SECTION 4.55(1A) APPLICATION TO AMEND SSD 10376 | 125 BATHURST STREET SYDNEY

This letter has been prepared by Urbis on behalf of Pitt Street Developer South Pty Limited (the applicant) with regards to a Section 4.55(1A) application to modify SSD 10376 which applies to the Pitt Street South Over Station Development (OSD) at 125 Bathurst Street, Sydney.

The modification application seeks to revise the maximum RL building height of the development, relocate louvres from the southern façade to the western facade, revise the adaptable apartment floor plans, and add a window on Level 7 of the approved State Significant Development (SSD).

Figure 2 Louvre location on western elevation (blue line indicates approved building envelope)

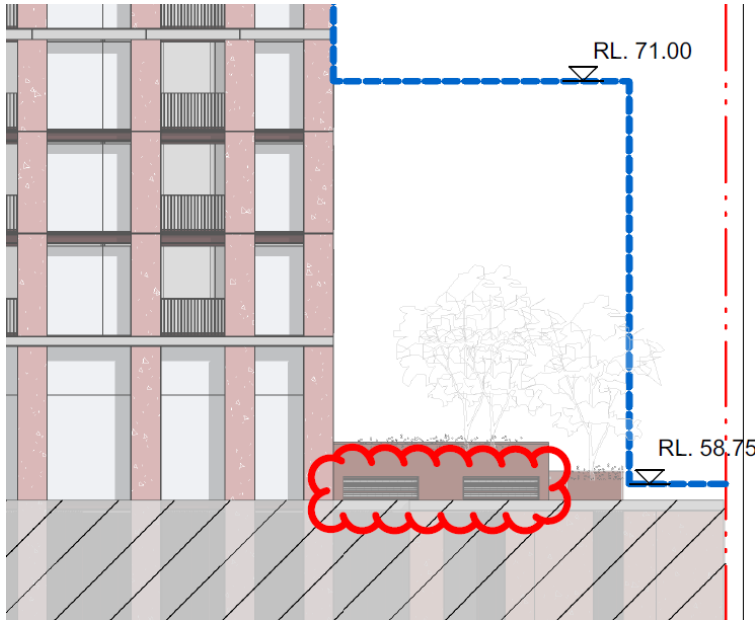
- Revise the approved plans to delete louvres on the southern façade at level 06 and relocate louvres to the western façade of the plant at level 06.

Updates provided in the Architectural Plan reflect the revised louvre location illustrated in **Figure 2**. This is a minor change to the window façade and is necessary due to the stair pressurisation intake being relocated.

Figure 3 Pitt Street South OSD proposed building envelope

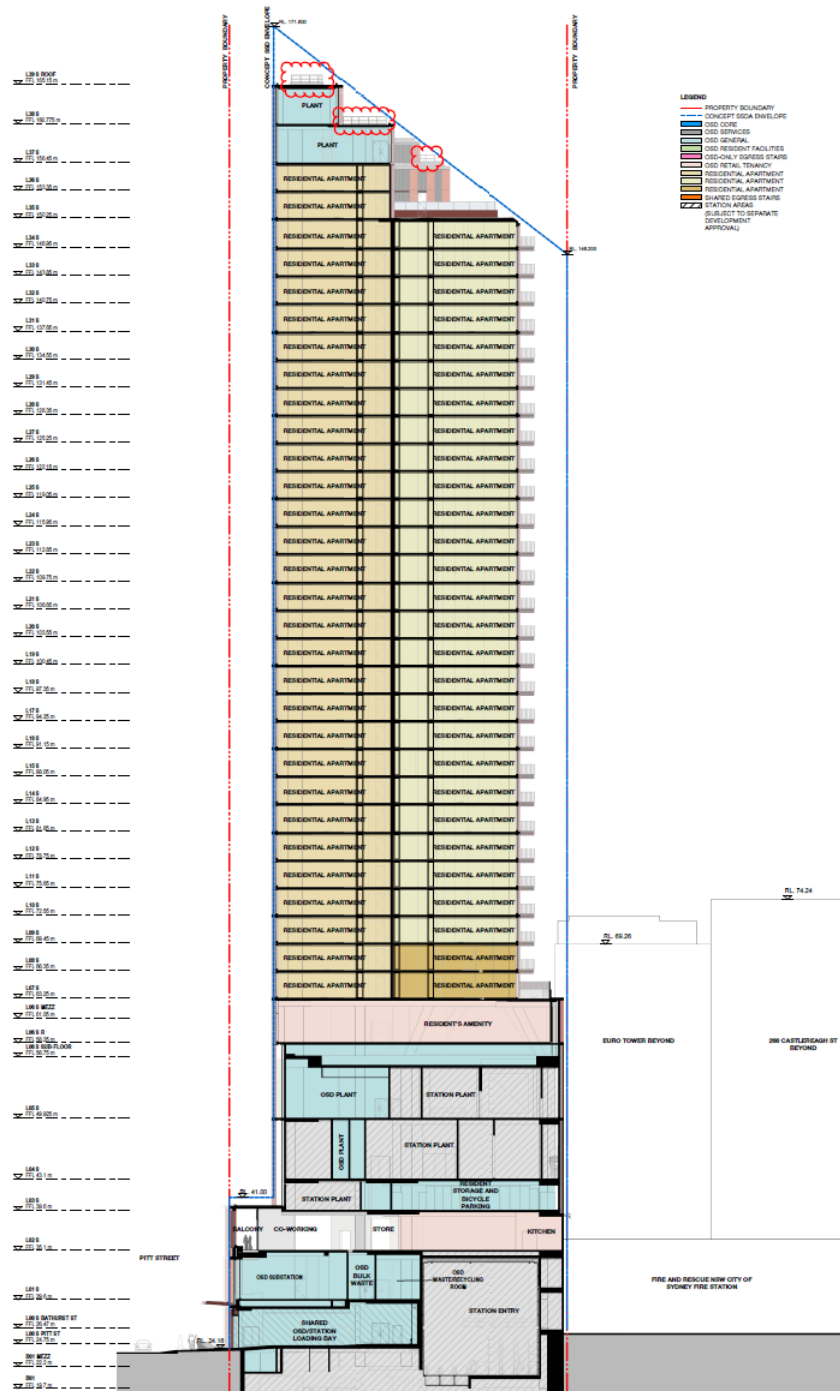
- Revise condition B11 which notes the approved maximum building height (RL) and permits certain building services that protrude beyond the maximum height.

The maximum building height permitted by condition B11 requires minor uplift from RL165.35 to reach an overall height of **RL166.35** to allow for the building envelope to include:

- Two hot water generator flues protruding 600mm above RL165.35
- Six air terminals protruding 800mm above RL165.35
- Top of handrail protruding 1m above RL165.35

The Architectural Plan illustrating the proposed components of the building that will exceed RL 165.35 within this amendment is illustrated in **Figure 3**.

Figure 4 Adaptable Apartment updates Levels 11-13

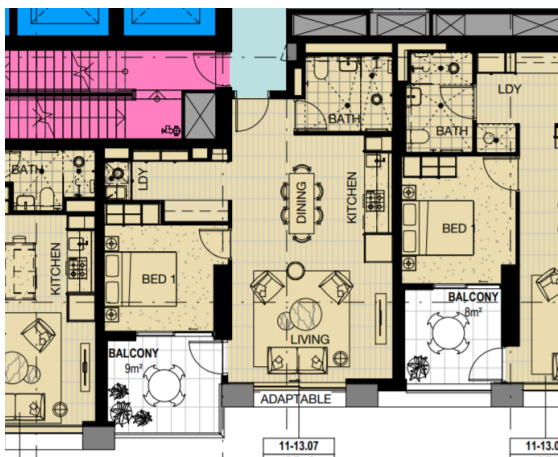
- Minor update to the nominated Adaptable Apartments to reconfigure floorplan design to incorporate Australian Standard AS2499 stated in condition B30. The changes required include:

- Minor changes to five adaptable apartments (3 x typical one bedroom, 2 x typical two bedroom) on Level 11-13.06 (DWG-931141) and Level 33-34.06 (DWG-933341).
- Levels 11-13 have altered the bathroom configuration to allow greater space for accessibility and moveability through the doorway and bathroom and more clearly labelled 'adaptable one bed apartment'. This is shown through red clouding in **Figure 4**, extracted from the updated Architectural Plans.
- Level 33-34 plans have re-located the laundry location to allow for greater space within the bathroom and doorway, enhancing accessibility and moveability. Also, providing clearer labelling of 'adaptable two bed apartment'. This is clouded red in **Figure 5** extracted from the updated Architectural Plans.
